Access Compliance Report

Public Rights-of-Way

Intersection ID: 10037555	Main Street: SELWYN_AV	Cross Street: N/A	Location: NW
ADA ID: 257EC00C3E58	Ramp Type: Perp	Initial Pass/Fail: Fail	Overall Compliance: No
		Severity Score: 12.5

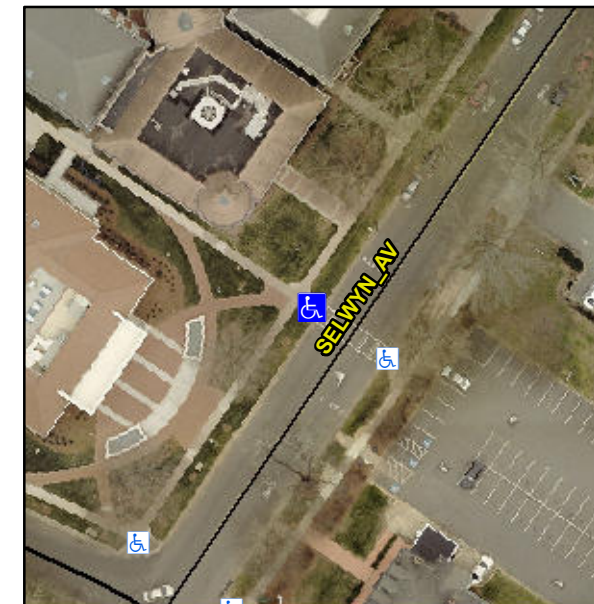
R304.2.2

Compliance	Description	Data	Compliance	Description	Data
N/A	Ramp Length (in)	178.0	No	Ramp Slope (%)	8.6
Yes	Ramp Width (in)	76.5	Yes	Ramp XSlope (%)	0.8
N/A	Flare Type LT	N/A	N/A	Flare Type RT	N/A
N/A	Flare Slope LT (%)	N/A	N/A	Flare Slope RT (%)	N/A
N/A	Flare Traversable LT?	N/A	N/A	Flare Traversable RT?	N/A
N/A	Landing Length (in)	N/A	N/A	DWS Provided?	N/A
N/A	Landing Width (in)	N/A	N/A	DWS Contrast?	N/A
N/A	Landing Slope (%)	N/A	N/A	DWS Length (in)	N/A
N/A	Landing X Slope (%)	N/A	N/A	DWS Full Width?	N/A
N/A	Landing Curb? (Y/N)	N/A	N/A	DWS Offset (in)	N/A
N/A	Shared Landing?	N/A			
N/A	Gutter Ponding?	N/A	N/A	Gutter Slope (%)	N/A
N/A	Gutter Lip Ht (in)	N/A	N/A	Gutter X Slope (%)	N/A
N/A	Painted X Walk1?	Yes	N/A	Painted X Walk2?	N/A
	X Walk 1 Direction	To SE		X Walk 2 Direction	N/A
N/A	X Walk 1 Width (in)	109.0	N/A	X Walk 2 Width (in)	N/A
	X Walk 1 Slope (%)	5.7		X Walk 2 Slope (%)	N/A
	X Walk 1 X Slope (%)	1.0		X Walk 2 X Slope (%)	N/A

Remove & Replace Entire Ramp.
